Airworthiness Directive

96-12-22 CESSNA AIRCRAFT COMPANY: Amendment 39-9665; Docket No. 93-CE-54-AD.

Figure 1. Oil Filter Adapter Installation

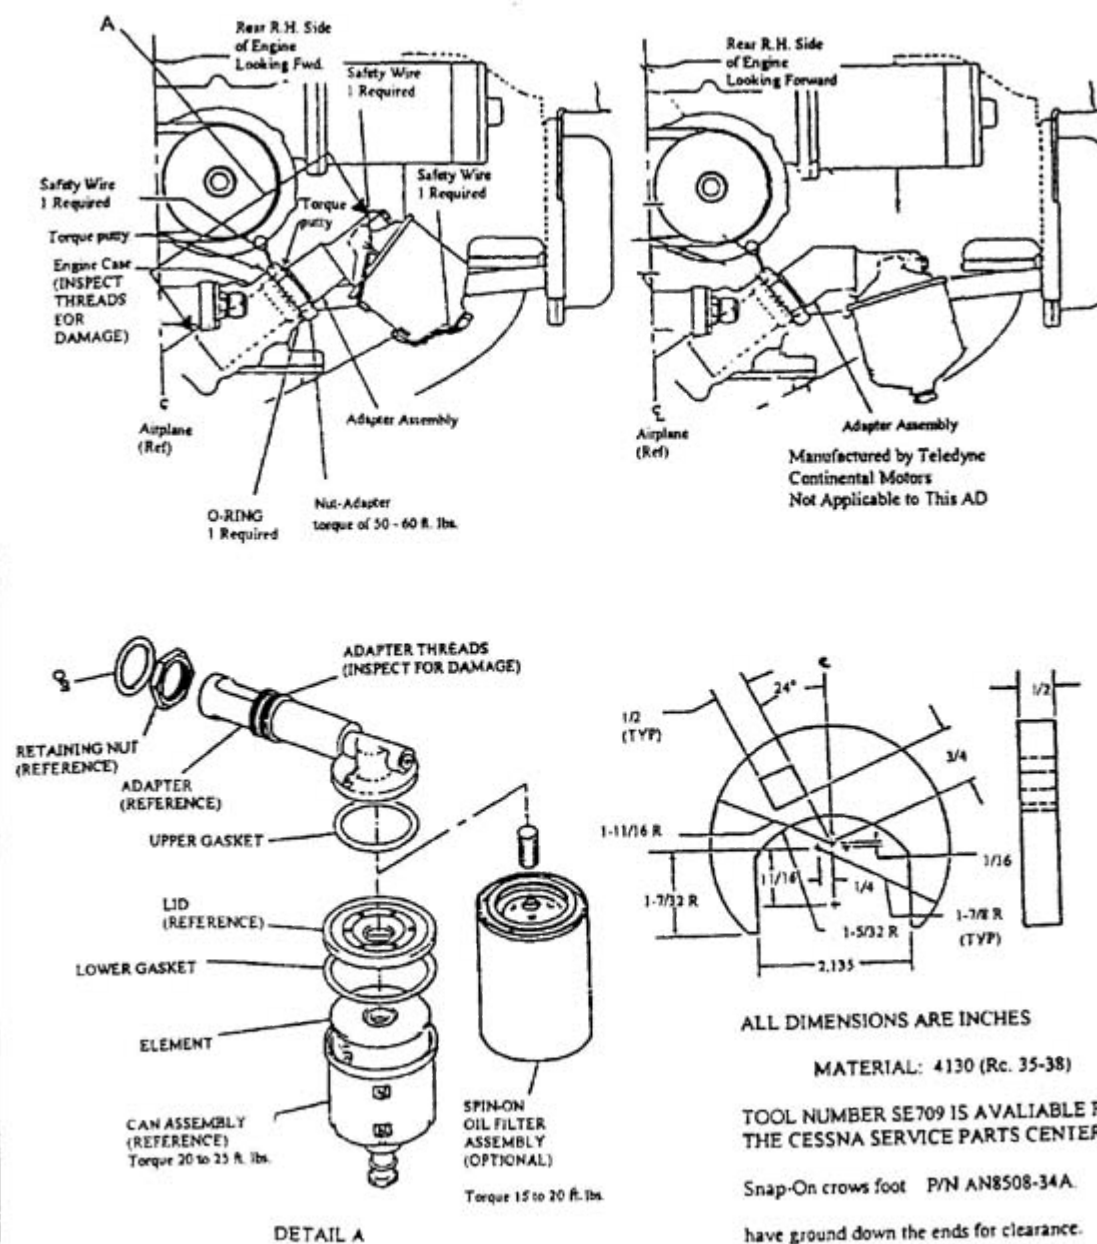
NOTE 2: This AD does not apply to engine oil filter adapter assemblies manufactured by Teledyne Continental Motors (See Figure 1 of this AD).

(a) For airplanes with engine oil filter adapter assemblies that do not have torque putty between the engine filter adapter assembly, nut, and oil pump housing, accomplish the following:

- (1) Inspect the adapter locking nut installation for evidence of oil leakage.
 - (2) Check the torque of the adapter nut installation and ensure that the torque value is within the limits of 50 through 60 foot pounds.

- (3) If evidence of oil leakage is found or the torque is not within the 50 through 60-foot pound limit, prior to further flight, remove the adapter and filter assembly, and:

- (i) Inspect the threads of the adapter assembly and engine for signs of damaged or cracked threads; and
 - (ii) Replace any adapter assembly and engine oil pump housing (if necessary) that have evidence of thread damage or cracks.

- (4) Apply torque putty between the engine filter adapter assembly, nut, and oil pump housing as specified in Figure 1 of this AD.
 - (5) Reassemble the engine oil filter assembly.
